Planning Commission Agenda Item

Date: October 9, 2024

SUBJECT: FDP-08-2024 TROPICAL AND WALNUT. Applicant: DR HORTON. Request: A Final Development Plan in a PUD (Planned Unit Development District) to Develop an 81-Lot, Single-Family Residential Subdivision. Location: Northwest Corner of Tropical Parkway and Walnut Road. (APN 123-30-201-007) Ward 1. (For Possible Action)

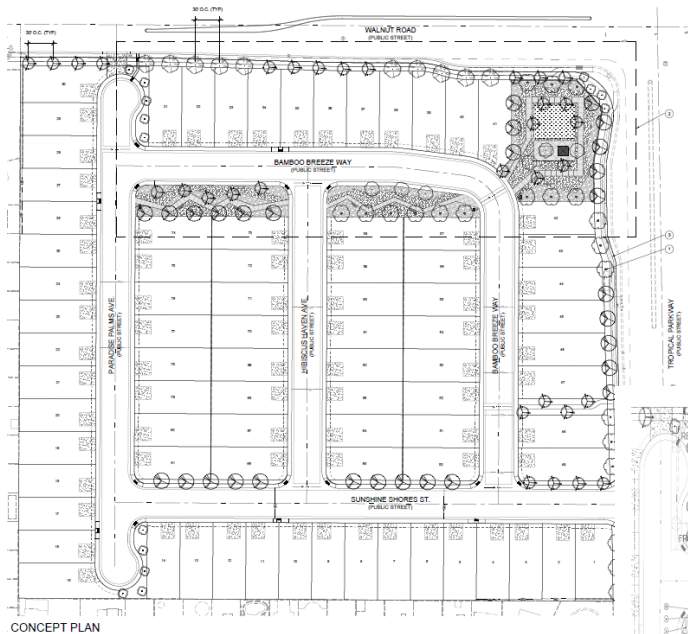
The submitted elevations indicate a two-story dwelling with a standard two (2) car garage. According to the proposed elevations, the dwellings would consist of primarily a stucco exterior, painted in three (3) different earth tone colors and a concrete tile pitched roof or tile shed style roof. The colored elevations provided generally comply with the design standards and are finished in earth tones indigenous to the Las Vegas Valley. However, the proposed elevations for the residential subdivision should incorporate additional architectural detailing on the front elevations. This can be addressed during the building permit process. The elevations submitted indicates three (3) distinct elevations will be offered per model for three (3) dwelling types consisting of 2,436 square feet up to 3,000 square feet. A subdivision development with 76-100 dwellings is required to provide three models units. Based on the size of the development three (3) models are required.

4. The elevations shall incorporate additional architectural detailing on the front of the dwelling.
5. The following amenities shall be provided within the open space areas: a tot-lot with EPDM surfacing; a barbeque area; a shaded ramada; benches; picnic areas; open turf areas; and dog station areas.
6. All driveways within the subdivision shall be made from brick or concrete pavers.
7. Setbacks for the lots are as follows:
 - Front setback – 10 feet (20 feet to garage)
 - Side yard setback – 5 feet
 - Corner side setback – 10 feet
 - Rear setback – 10 feet

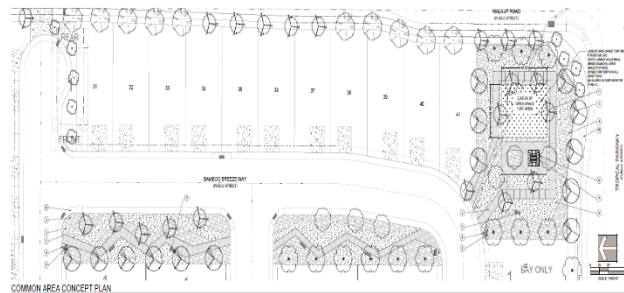
The applicant is required to provide 28,350 square feet of open space. The open space for a PUD with a lot size of 3,799 or less is calculated at 350 square feet per dwelling unit. The proposed site plan indicates 30,487 square feet of useable open space will be provided. The site plan indicates common element “D” which is located between lots 41 and 42 as the central location for the open space. The remaining open space is distributed throughout the project as common elements E, F and G. The applicant submitted an open space plan, which indicates the following amenities to be provided; a shaded ramada; benches; picnic table; open turf areas; trash receptacles and dog station areas. However, per the approved PUD (ZN-15-2023) additional amenities were also required: a tot-lot

with EPDM surfacing and or a barbeque area. The applicant should provide all the approved amenities in a revised open space plan. The open space plan and amenity list will be reviewed during the building permit process.
